SDP Document Location	Update Made:																		
Page 14 – underneath caption of figure 2.15	Added “Please refer to the site-specific landscape character assessment (Doc Ref OP5 Appendix 12.1) for further details regarding the site and its setting”.																		
Page 30 – section 4.2	<p>Under ‘Site Influences’ we have added ‘Existing views to the North Downs escarpment as shown’ and added views as per the mark up below:</p> <p>4.2 River Stour</p> <div data-bbox="465 517 728 619"> <p>AT A GLANCE</p> <ul style="list-style-type: none"> Natural, winding River Stour corridor creates peaceful and ecologically-rich informal park Strong built edge to A20 to re-imagine road as street Flat topography provides opportunity for orthogonal street pattern, contrasting with other areas </div> <div data-bbox="465 635 728 1005"> <p>SITE INFLUENCES</p> <ol style="list-style-type: none"> Topography is relatively flat, giving flexibility for a variety of street layout solutions - potential for a more orthogonal approach, to contrast with undulating areas of the site East Stour River and its extensive flood zone provides a green corridor through the area - opportunity to create an informal wetl

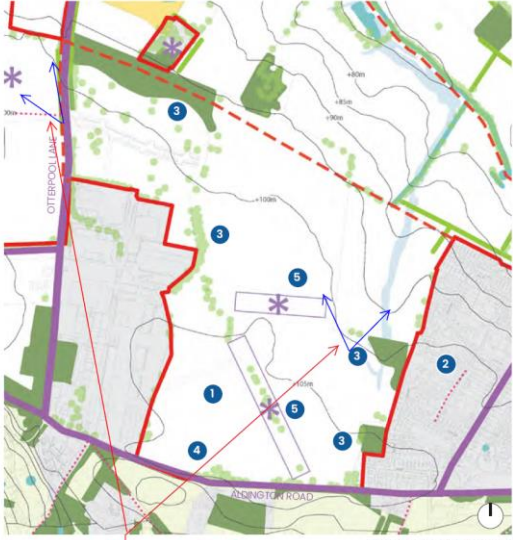
</div> <div data-bbox="739 475 1272 965"> <p><i>In response to Natural England's comments Page 13, Paragraph 7, the plan needs to acknowledge the presence of existing views to the North Downs escarpment as shown - add to 'site influences'</i></p> <p>Fig. 45. River Stour site influences</p> </div>	— Site boundary	Waterbody	- - - Character area boundary	High/low risk flooding area	Existing woodland	Existing settlement	SSSI	Railway	ACNB	Existing road	Existing trees	Existing footpath or bridleway	Existing hedgerow	Heritage site, visible/hidden	River	Scheduled Ancient Monument boundary (relating to barrows)		5m contours
— Site boundary	Waterbody																		
- - - Character area boundary	High/low risk flooding area																		
Existing woodland	Existing settlement																		
SSSI	Railway																		
ACNB	Existing road																		
Existing trees	Existing footpath or bridleway																		
Existing hedgerow	Heritage site, visible/hidden																		
River	Scheduled Ancient Monument boundary (relating to barrows)																		
	5m contours

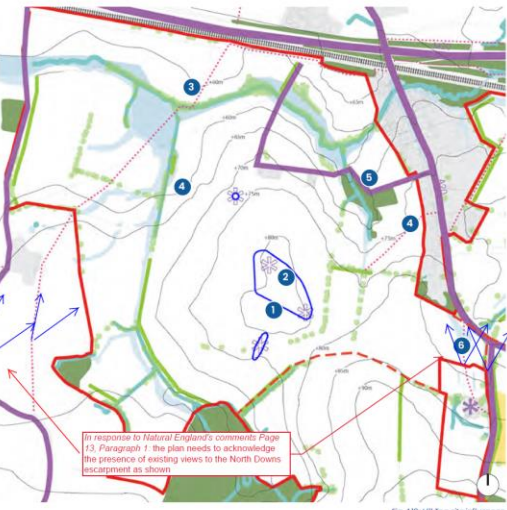
</div> <div data-bbox="779 341 1352 804"> <p>Fig 4.7: Country Park site influences</p> </div> <div data-bbox="943 863 1182 919"> <p><i>In response to Natural England's comments Page 13, Paragraph 1, the plan needs to acknowledge the presence of existing views to the North Downs escarpment as shown, and add to 'Site Influences'</i></p> </div>	— Site boundary	Waterbody	- - - Character area boundary	High/low risk flooding area	Existing woodland	Existing settlement	SSSI	Railway	ACNH	Existing road	Existing trees	Existing footpath or bridleway	Existing hedgerow	Heritage site, visible/hidden	River	5m contours		Scheduled Ancient Monument boundary (relating to barrows)
— Site boundary	Waterbody																		
- - - Character area boundary	High/low risk flooding area																		
Existing woodland	Existing settlement																		
SSSI	Railway																		
ACNH	Existing road																		
Existing trees	Existing footpath or bridleway																		
Existing hedgerow	Heritage site, visible/hidden																		
River	5m contours																		
	Scheduled Ancient Monument boundary (relating to barrows)																		
<p>Page 34 – section 4.4</p>	<p>Under 'Site Influences' added 'Existing views to the North Downs escarpment as shown' and added views as per mark up below:</p>

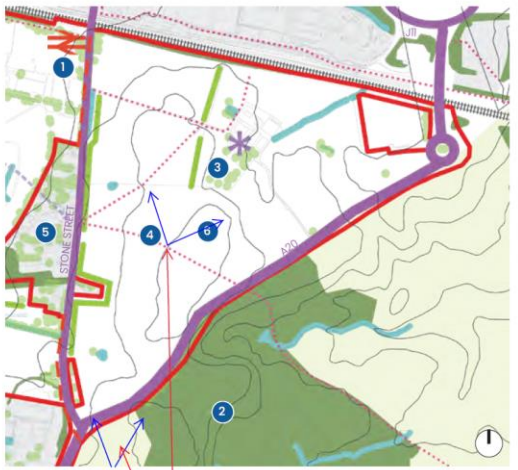
<p>34 Otterpool Park Strategic Design Principles</p>  <p><i>In response to Natural England's comments Page 13, Paragraph 1, the plan needs to acknowledge the presence of existing views to the North Downs escarpment as shown.</i></p> <p>Fig 4.8: Airfield Park site influences</p>		Site boundary		Waterbody		Character area boundary		High/low risk flooding area		Existing woodland		Existing settlement		SSSI		Railway		AONB		Existing road		Existing trees		Existing footpath or bridleway		Existing hedgerow		Heritage site, visible/hidden		River		5m contours				Scheduled Ancient Monument boundary (relating to barrows)
	Site boundary		Waterbody																																		
	Character area boundary		High/low risk flooding area																																		
	Existing woodland		Existing settlement																																		
	SSSI		Railway																																		
	AONB		Existing road																																		
	Existing trees		Existing footpath or bridleway																																		
	Existing hedgerow		Heritage site, visible/hidden																																		
	River		5m contours																																		
			Scheduled Ancient Monument boundary (relating to barrows)																																		
Page 36 – section 4.5	Under 'Site Influences' added 'Existing views to the North Downs escarpment as shown' and added views as per mark up below:

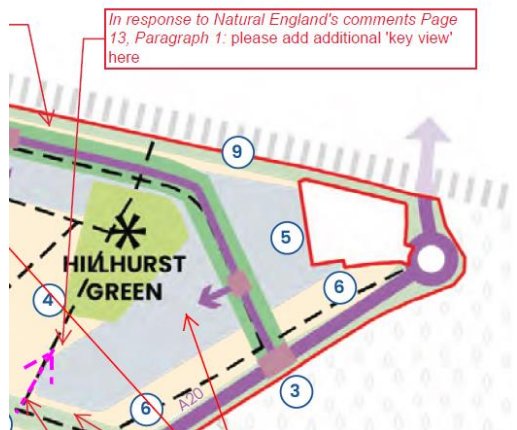
<p>Fig. 4J5: Hillhurst Farm site influences</p> <p><i>In response to Natural England's comments Page 13, Paragraph 1: the plan needs to acknowledge the presence of existing views to the North Downs escarpment as shown and add them to the site influences</i></p>	— Site boundary	Waterbody	- - - Character area boundary	High/low risk flooding area	Existing woodland	Existing settlement	SSSI	Railway	ACNB	Existing road	Existing trees	Existing footpath or bridleway	Existing hedgerow	Heritage site, visible/hidden	River	5m contours
— Site boundary	Waterbody																
- - - Character area boundary	High/low risk flooding area																
Existing woodland	Existing settlement																
SSSI	Railway																
ACNB	Existing road																
Existing trees	Existing footpath or bridleway																
Existing hedgerow	Heritage site, visible/hidden																
River	5m contours																
<p>Page 41</p>	<p>Added a key view to this plan so consistent with approach taken on other similar plans.</p>  <p><i>In response to Natural England's comments Page 13, Paragraph 1: please add additional 'key view' here</i></p>

Page 34 and page 38 – section 4.6	To the 'Site influences' section added "Relationship to existing community". Added the same to the character area near Lymgne.
Page 40 – section 4.7	Under 'Site Influences' added 'Existing views to the North Downs escarpment as shown' and added views as per mark up below:
